VILLAGE OF SUSSEX
SUSSEX, WISCONSIN

Minutes of the Architectural Review Board (ARB) meeting held on May 4, 2016.

MEMORANDUM

RE: ARB meeting for May 4, 2016

1 PROPOSED SITE PLAN
 SCALE: 1" = 40'-0"

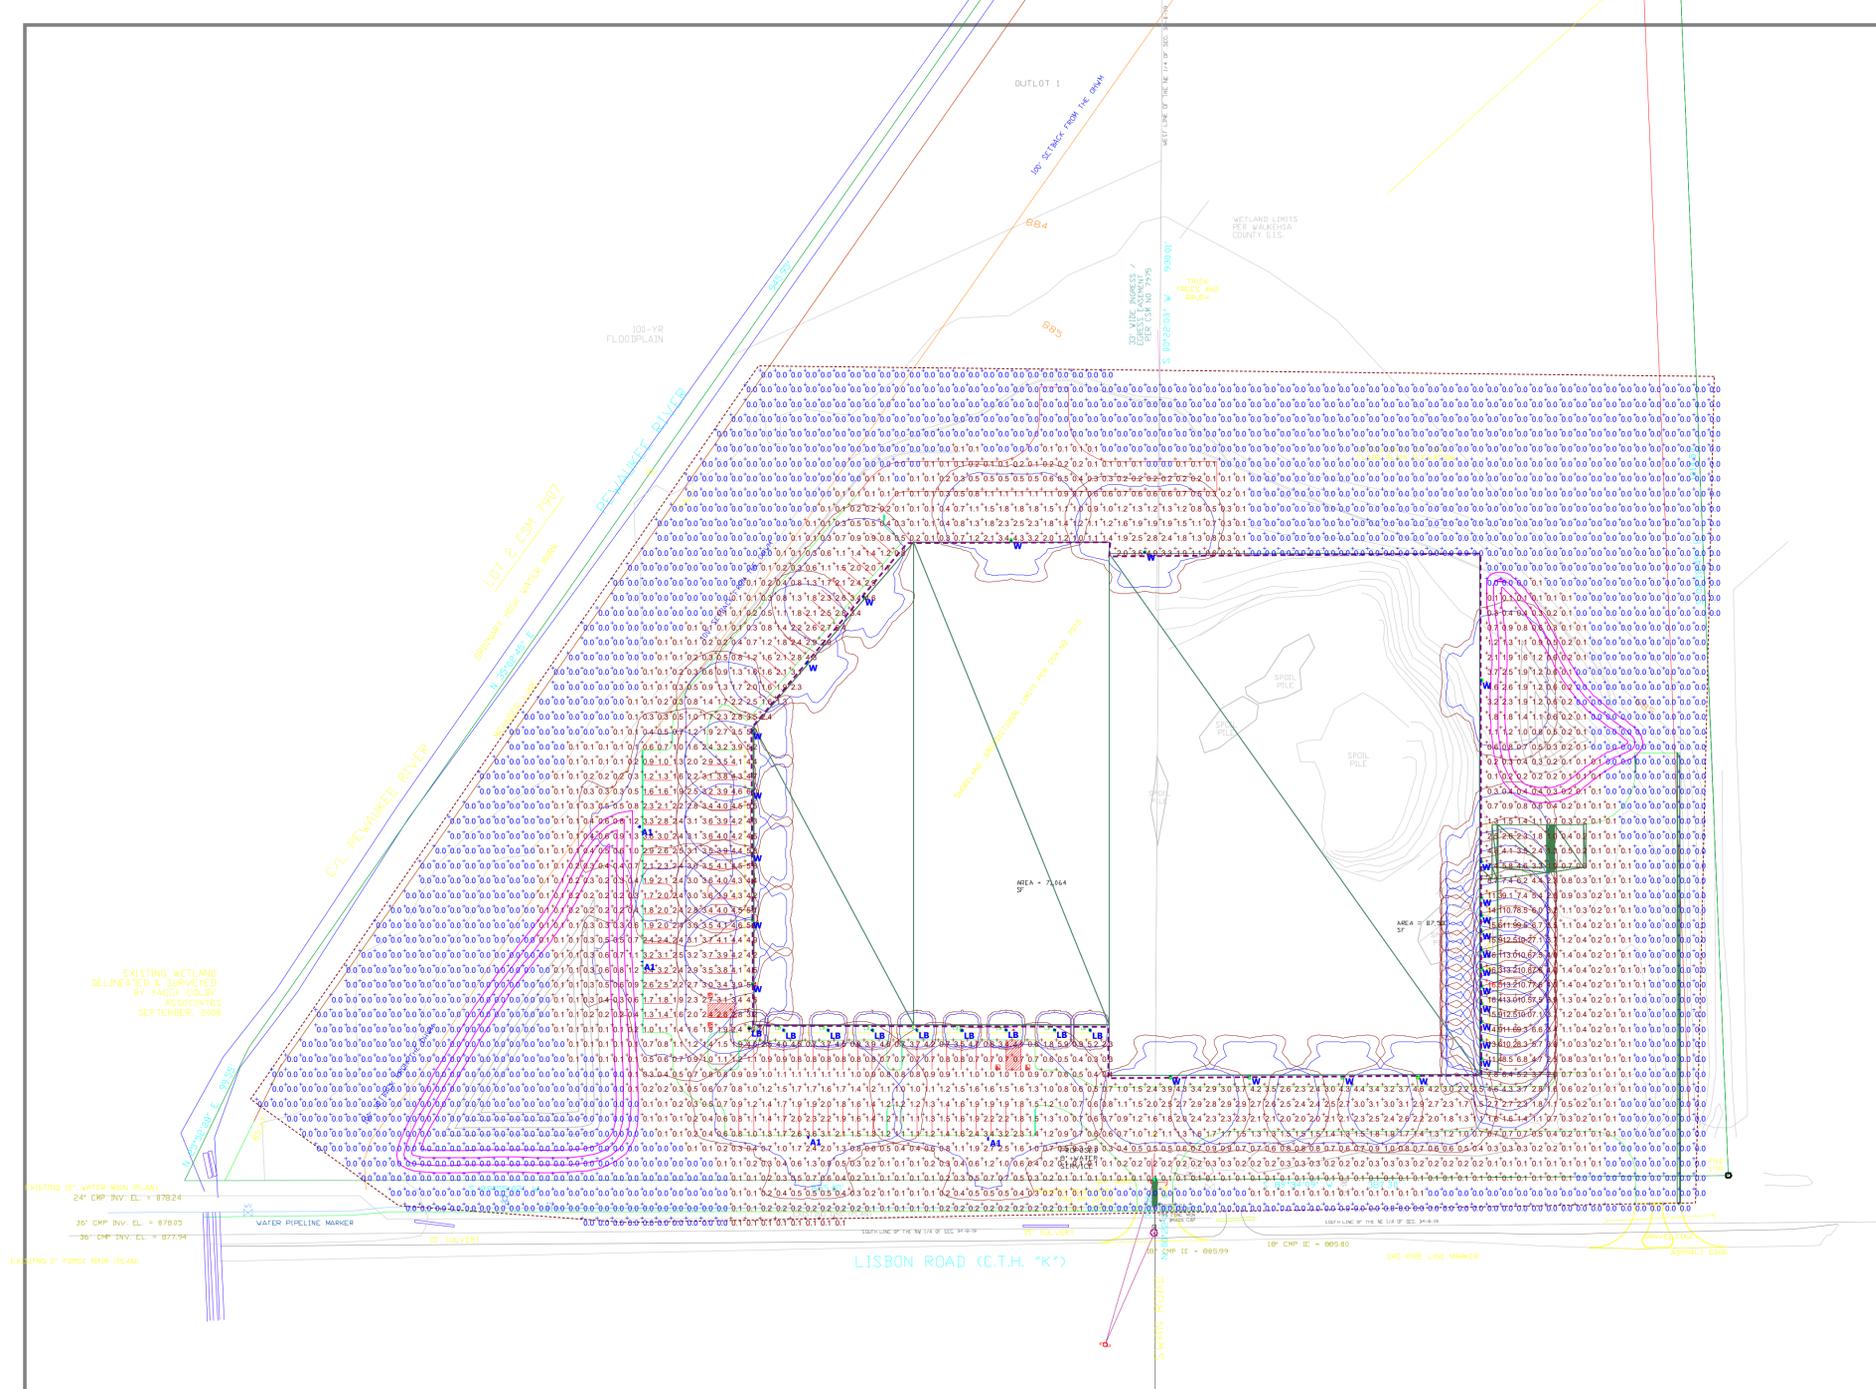
Mr. Hertzfeldt stated the site entrance will be across from Swan Road and to the east will be a right in and right out only access point.

- Parking lot to have curb or barrier and sidewalk adjacent to parking lots to be 6' wide.
- County highway improvements to be reviewed.

- Adjust sidewalk width along parking lot and add curb or barrier at parking lot.
- Submit a rendering of the dumpster enclosure and approval to be made by the ADD.
- Metal panel to match the color of the prefinished precast walls. Metal panel wall will be allowed for a period of no more than 5 years after the date of occupancy is granted.
- Add windows to the west side of phase 2 spacing to match the front elevation.

2 WEST ELEVATION (PHASE 2 ONLY)
 SCALE: 1/16" = 1'-0"

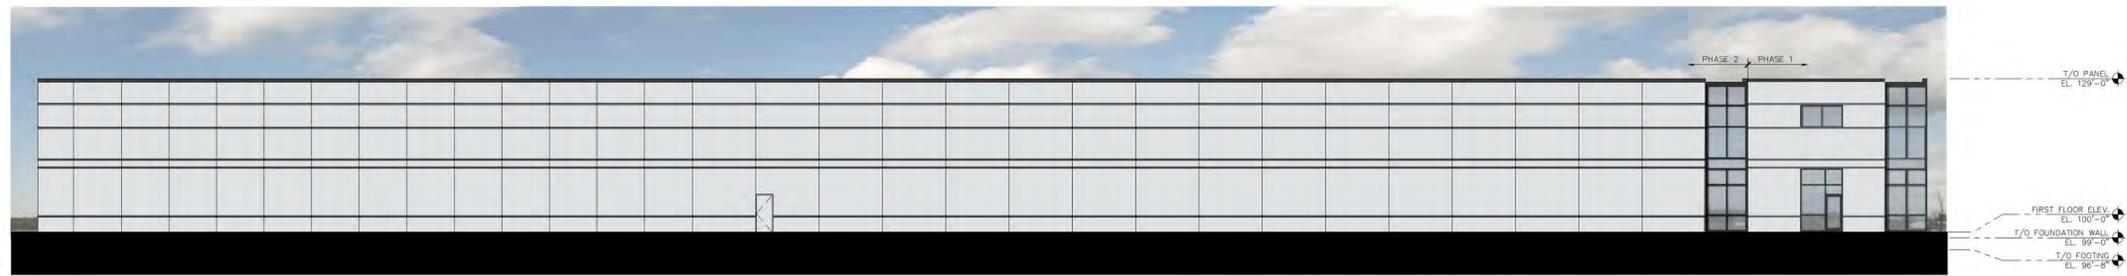
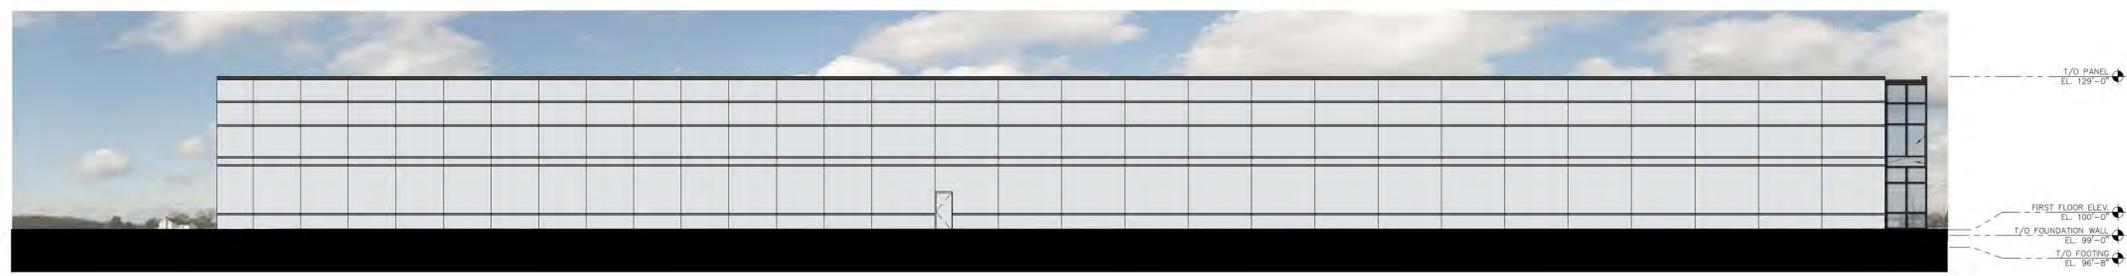
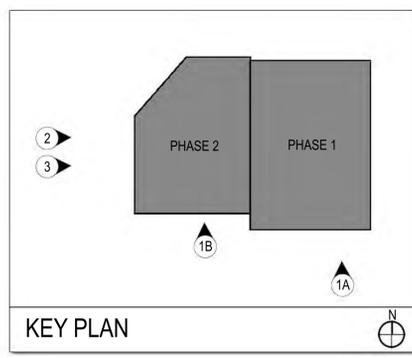
Mr. Dietrich stated he is fine with the metal panel wall but would like to see that there is a timeframe of removal if the second phase is not built. Mrs. Granicki stated she would like the color of the precast panels and the metal panels to be the same color or a close match in color.

Mrs. Fluet stated the west side wall of phase 2 building should have windows added. Mrs. Granicki stated the spacing of the windows should match the spacing on the front elevation. Mr. Dietrich stated windows are only necessary on the wall facing west and not the wall facing north west.

- Roof top units are to be screened from view.
- West side of building wall approximately 300' of the 350' wall will be metal panel. The consideration of the metal panel is for the ease of construction of phase 2.
- No rendering of the dumpster enclosure is indicated, plans and rendering must be submitted.

- Adjust sidewalk width along parking lot and add curb or barrier at parking lot.
- Submit a rendering of the dumpster enclosure and approval to be made by the ADD.
- Metal panel to match the color of the exterior walls of the prefinished precast walls.
- Add windows to the west side of phase 2.

1 PROPOSED MASTER LANDSCAPE PLAN

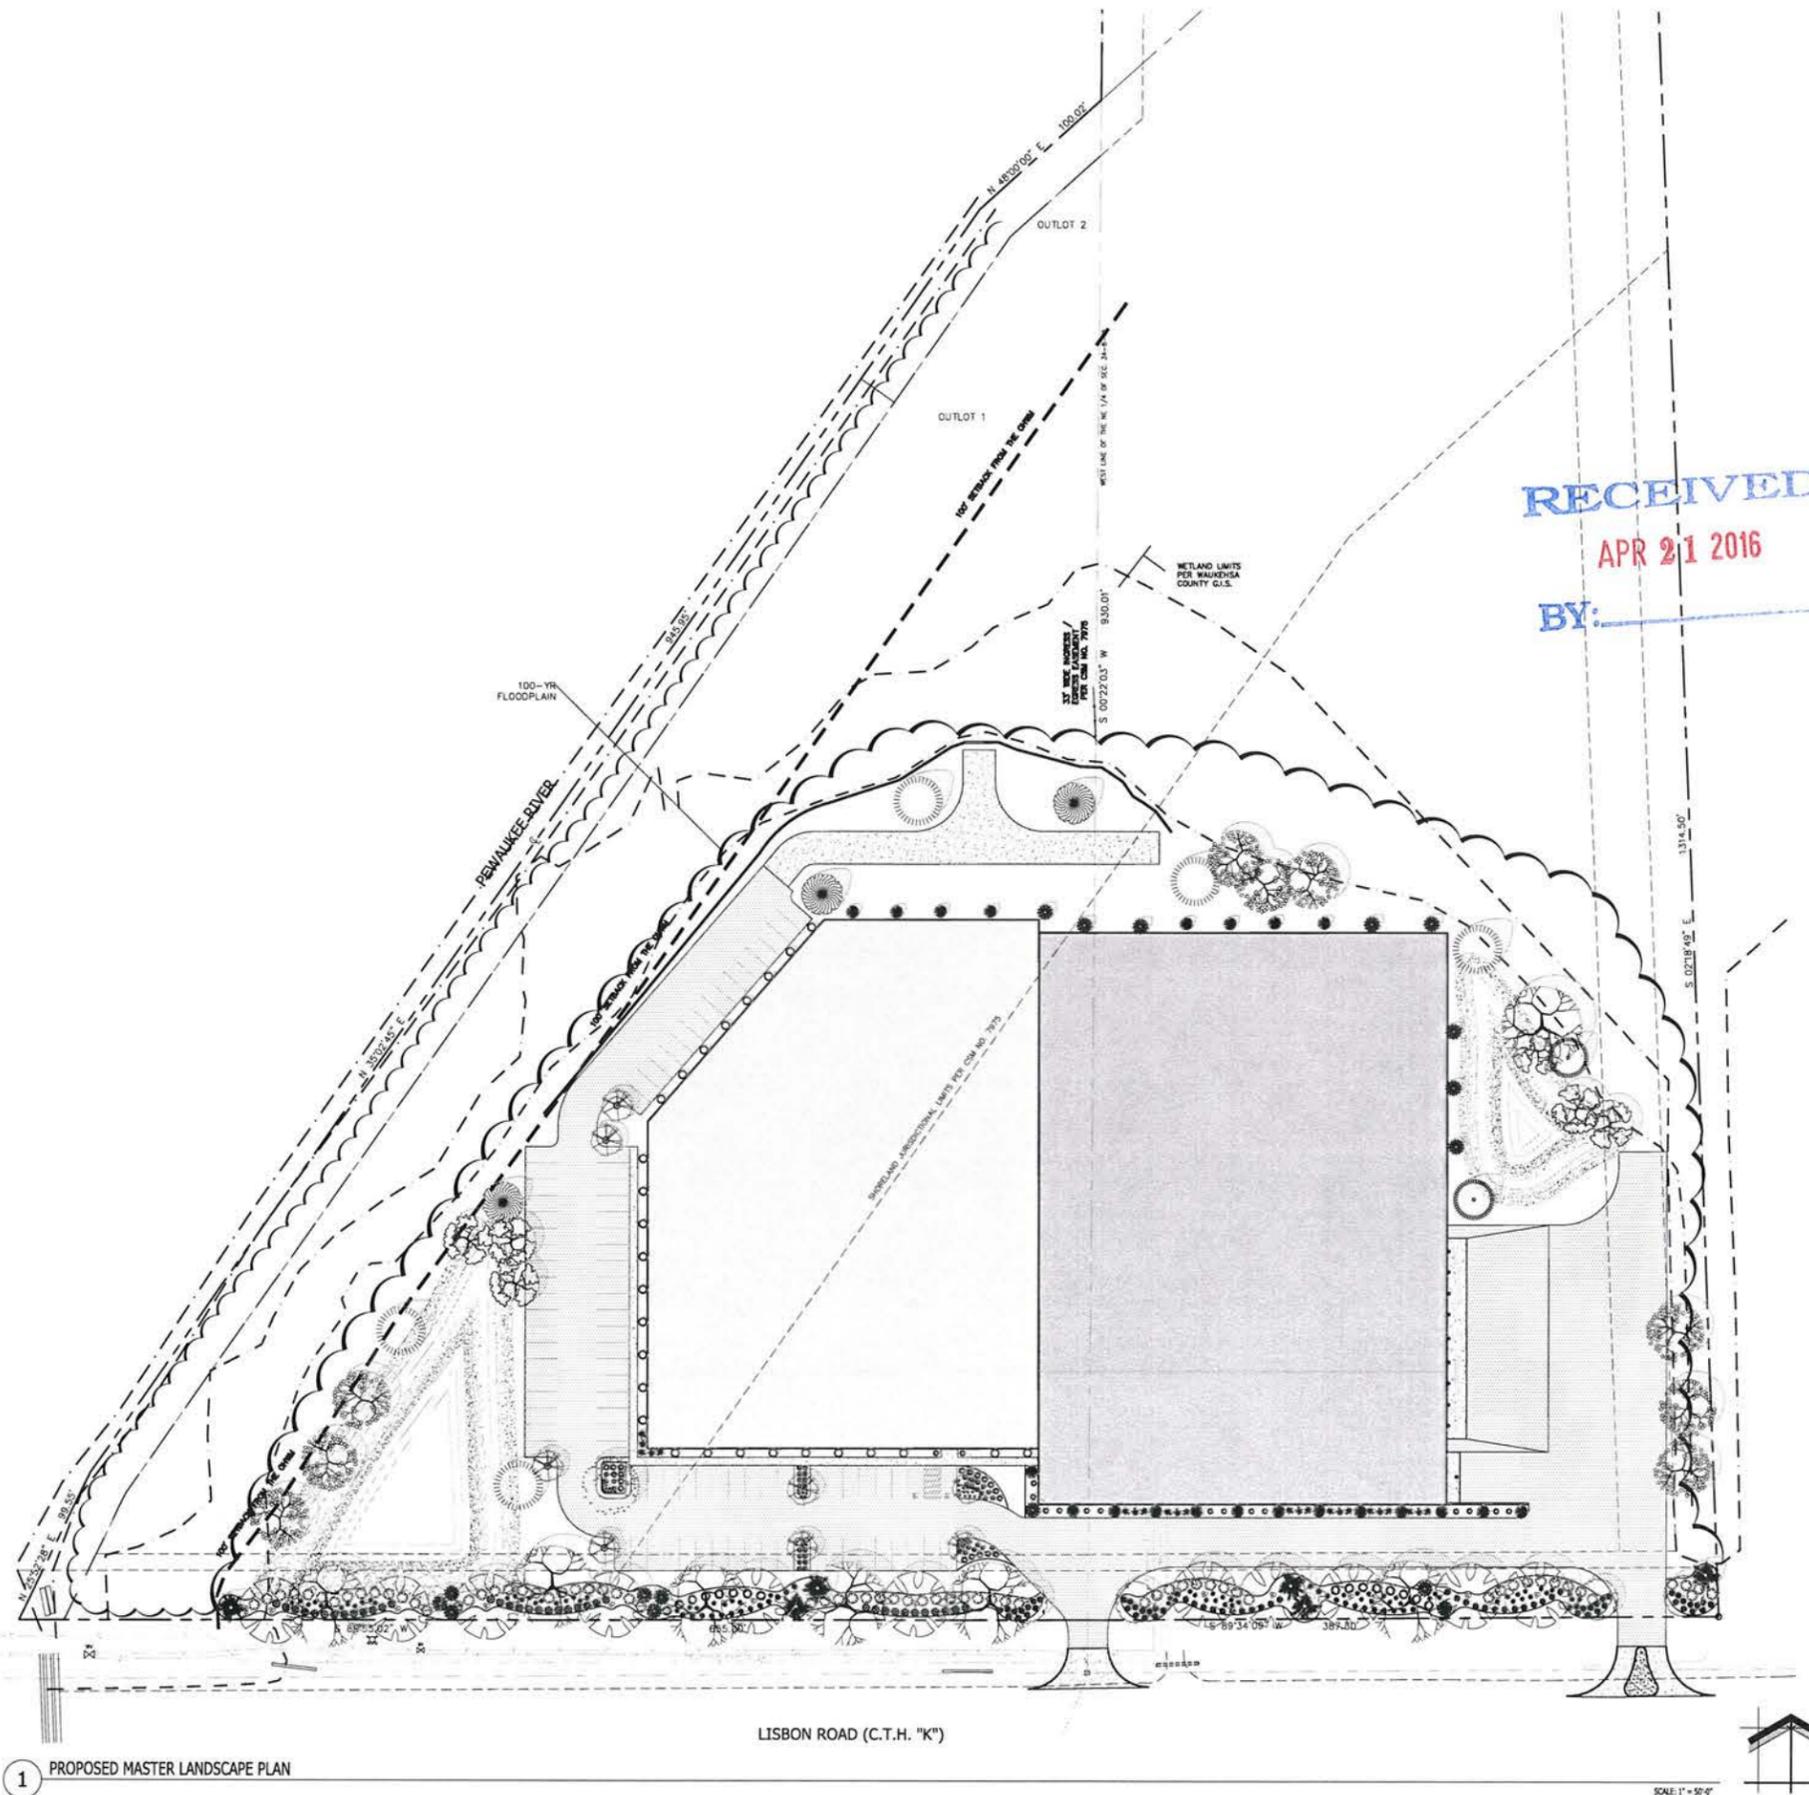
Mr. Hertzfeldt reviewed the landscape plan and stated all the plantings will take place with phase 1 and any planting around phase 2 will be delayed, most of the landscape plants are in the front and around the storm ponds.

Meets the requirements, the plans call for 143 trees/evergreens and 418 shrubs/flowers. Tree preservation report still must be submitted to the Tree Board for consideration.

A DOUBLE SIDED INTERNALLY ILLUMINATED MONUMENT SIGN w/ L.E.D. MESSAGE CENTER

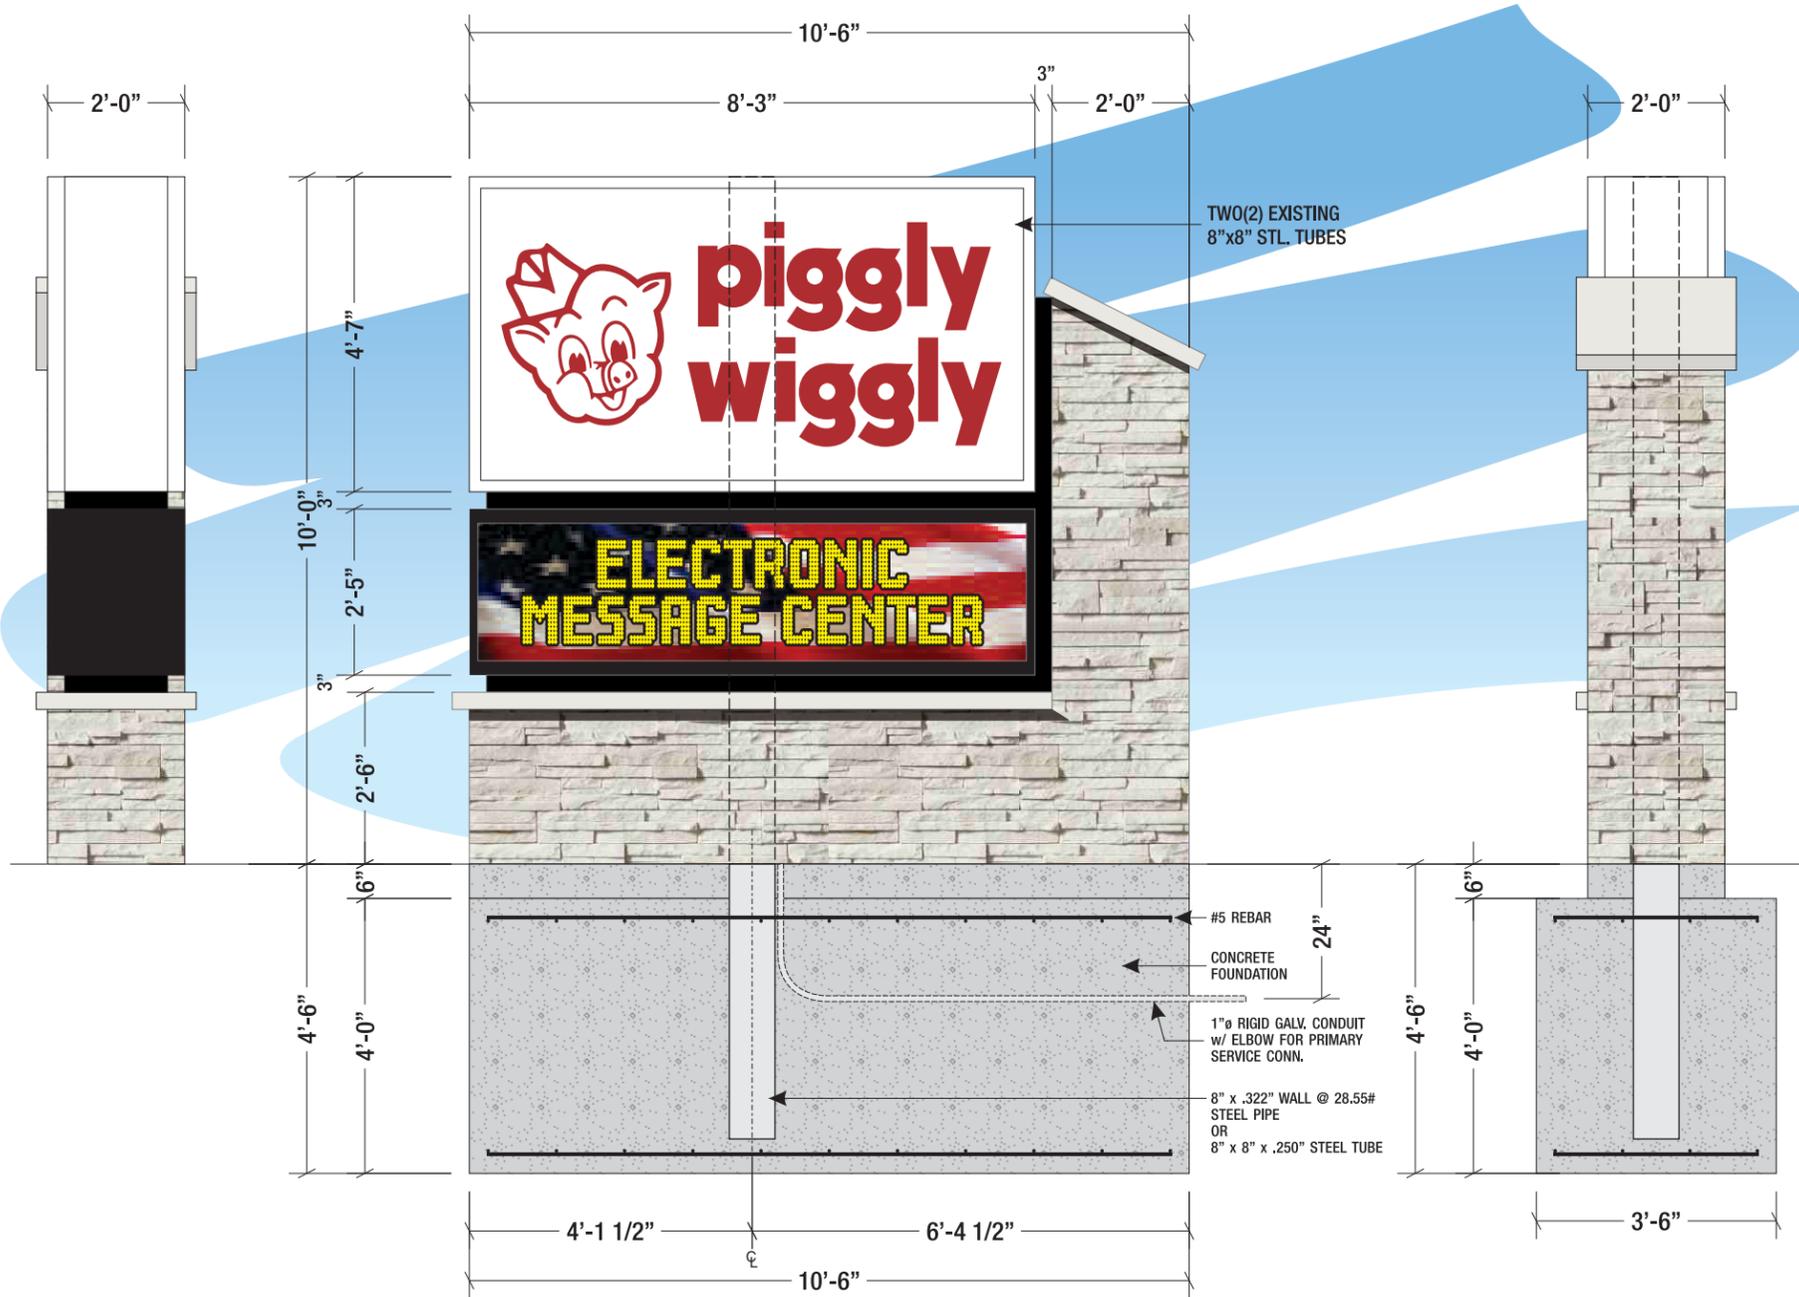
No one was present for this matter. Mrs. Fluet reviewed the memo (copy attached). Mrs. Granicki stated she would like to see the pillar top not angled. Mrs. Schauer agreed.

A motion by Granicki, seconded by Schauer to recommend to the Plan Commission to approve the ground sign with electronic message area for Piggly Wiggly with the side pillar to be flat with a stone cap.

Staff recommends: Staff recommends the ARB recommend to the Plan Commission to approve the ground sign with electronic message area for Piggly Wiggly, subject to the address should be added to the base of the sign and due to the location of the sign, landscape materials will not be required.
